Product Change Notification / CENO-04NLGN370

CCB 5123 Initial Notice: Qualification of MTAI as an additional assembly site for selected ATECC108A, ATECC508A, ATSHA204A, ATECC608A, ATECC608B and ECC608-TFLXWPC device families available in 8L SOIC (3.90mm) package.

CCB 5123
Pre and Post Change Summary
PCN #: CENO-04NLGN370

ASSH

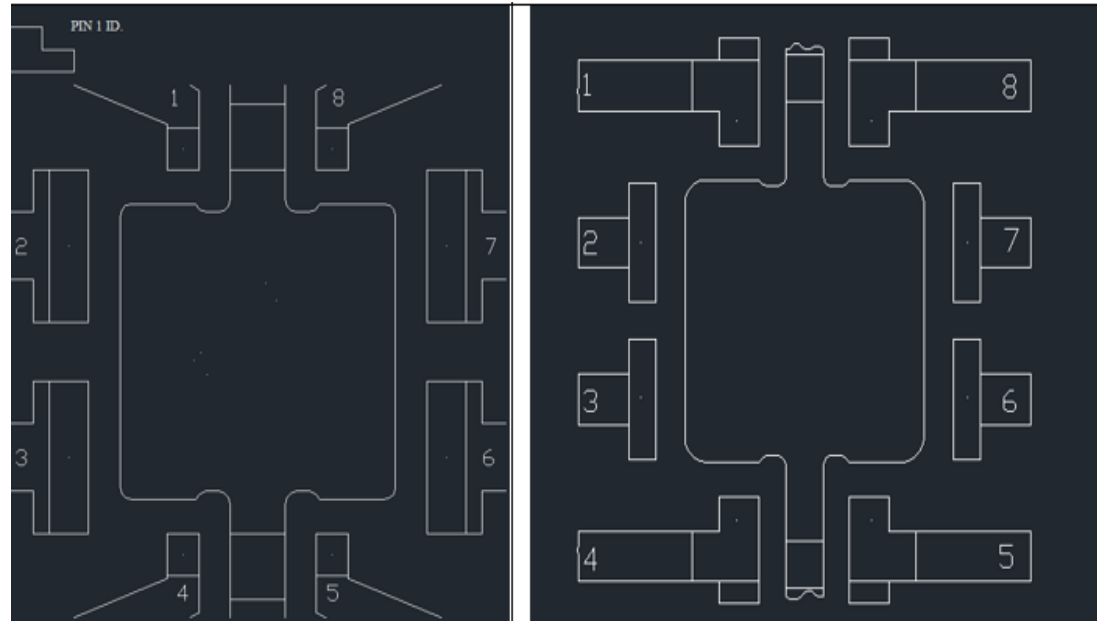
Lead frame DAP surface prep	PPF
Lead Plating	NiPdAu
Lead-Frame Paddle Size	70 x 70 / 90 x 90

MTAI

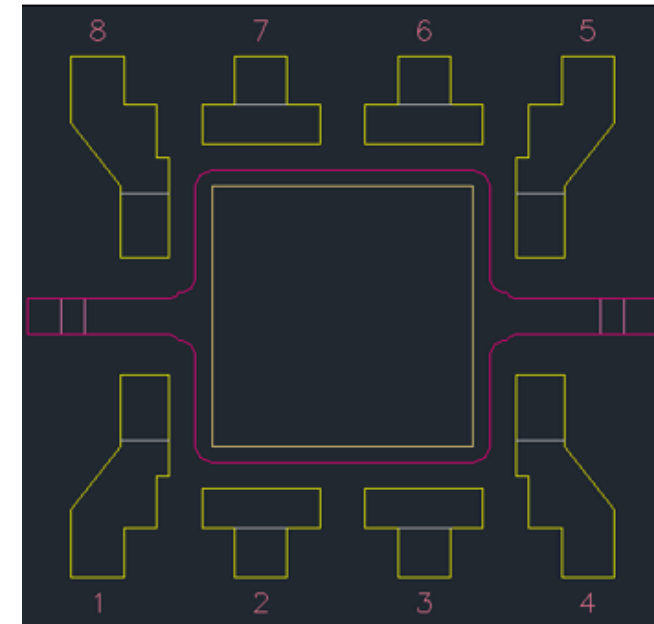
Lead frame DAP surface prep	Bare Cu
Lead Plating	Matte tin
Lead-Frame Paddle Size	90 x 90
